Responses to Comments

on the Additional Investigation Results

National Aeronautics and Space Administration, Jet Propulsion Laboratory, Pasadena, California

December 2008

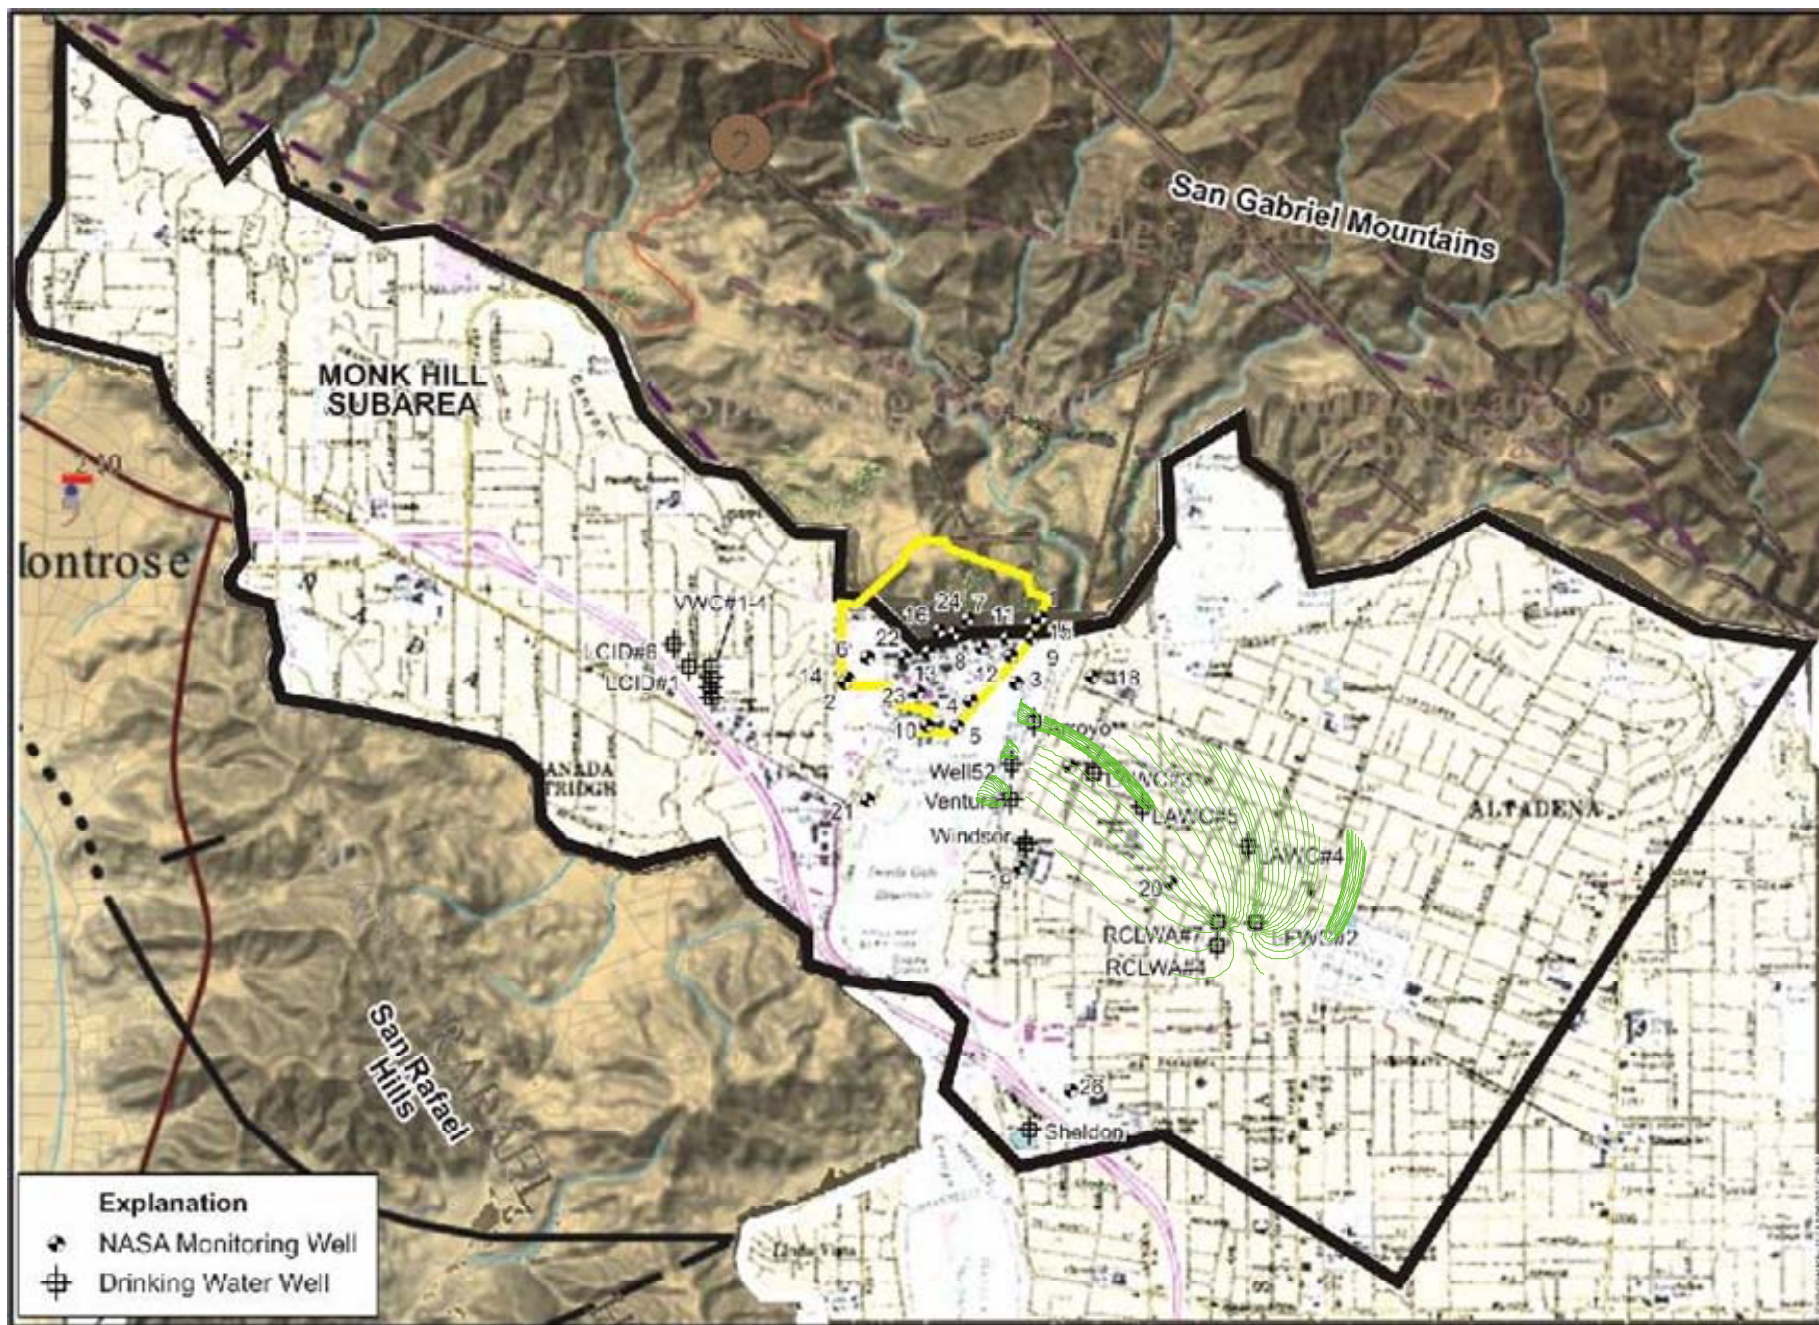
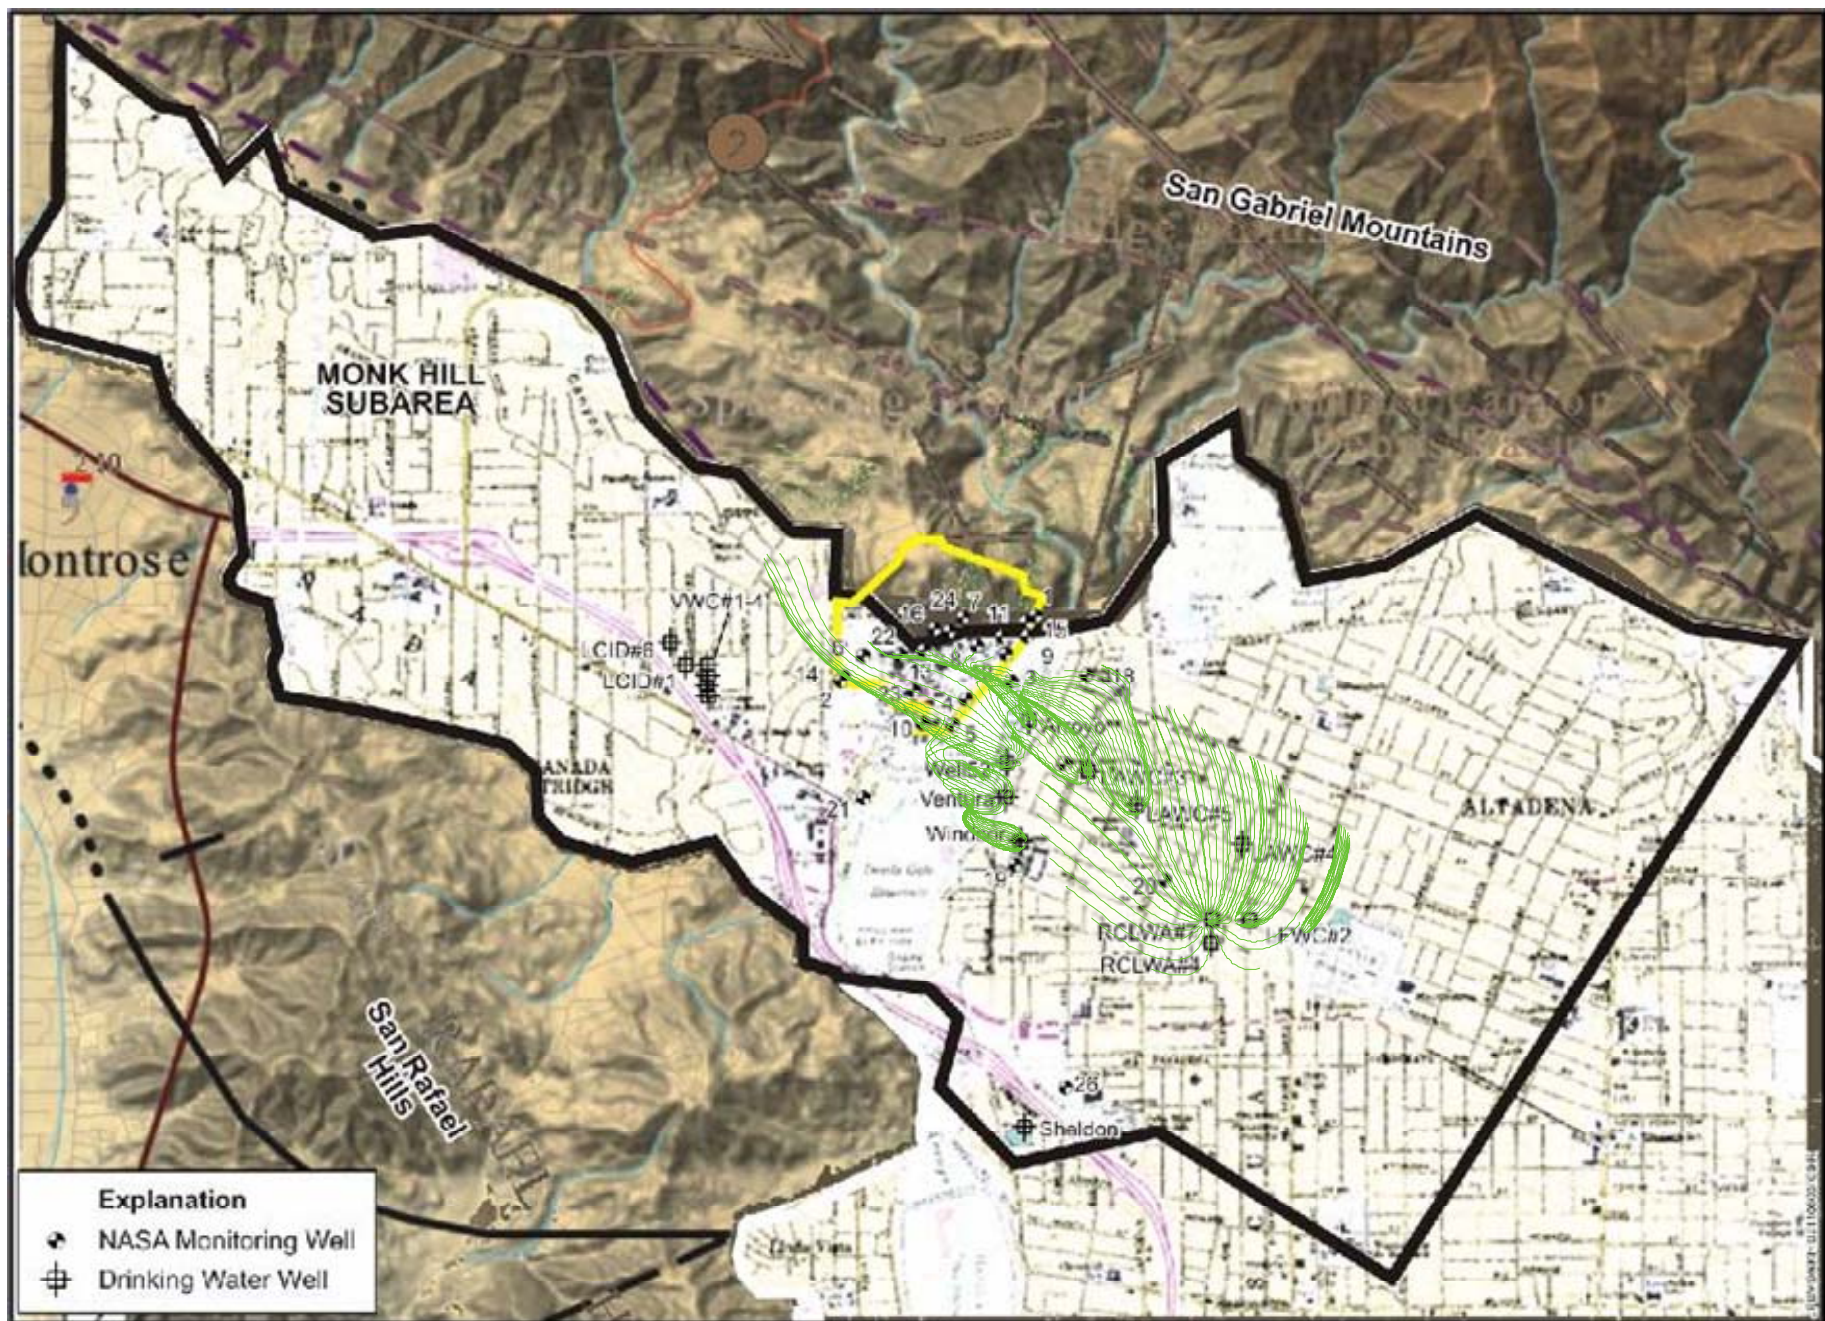
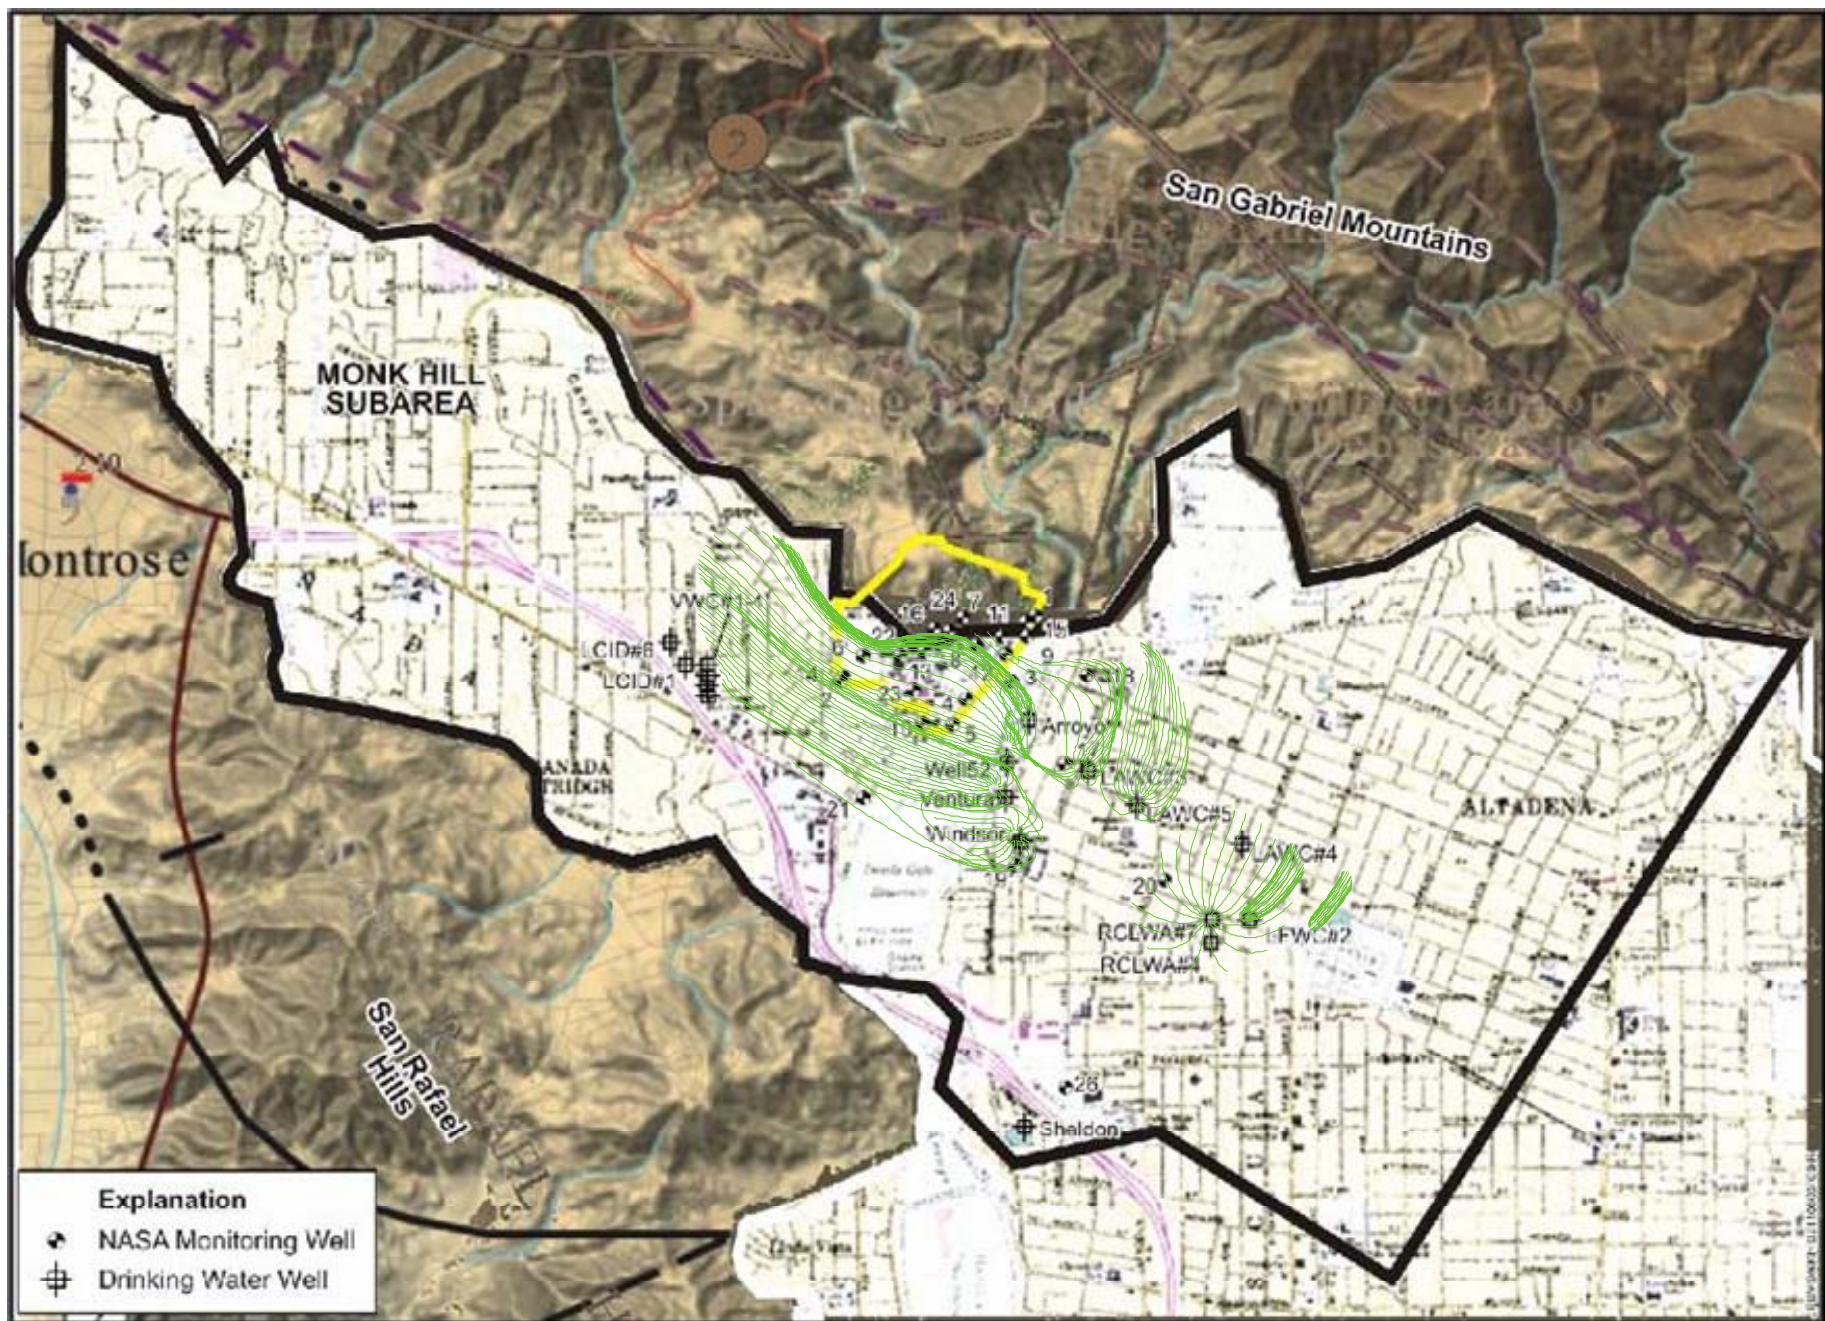
EPA Comment No. 3 – The RBMB model is a two layer regional model, and the JPL model is a more localized site model consisting of four layers. Figures 2, 3, and 4 show particle tracking simulation results. Considering the existence of the vertical hydraulic gradient, the particle paths would look different for each layer. The composite paths shown in Figures 2, 3, and 4 are then not sufficient to describe the three-dimensional nature of the particle paths. Please show the information for each layer rather than as a composite. Please show the particle paths in cross-section as well as forward paths originating at JPL.

As requested, Figures A1-1, A1-2, A1-3, and A1-4 have been prepared to show capture zones in each of the four zones defined in the JPL Modeling Report. A lithologic cross section representing a transect from the JPL source area to the downgradient production wells is shown in Figure A1-5. These figures show that the production wells provide vertical and horizontal containment of chemicals originating from JPL.
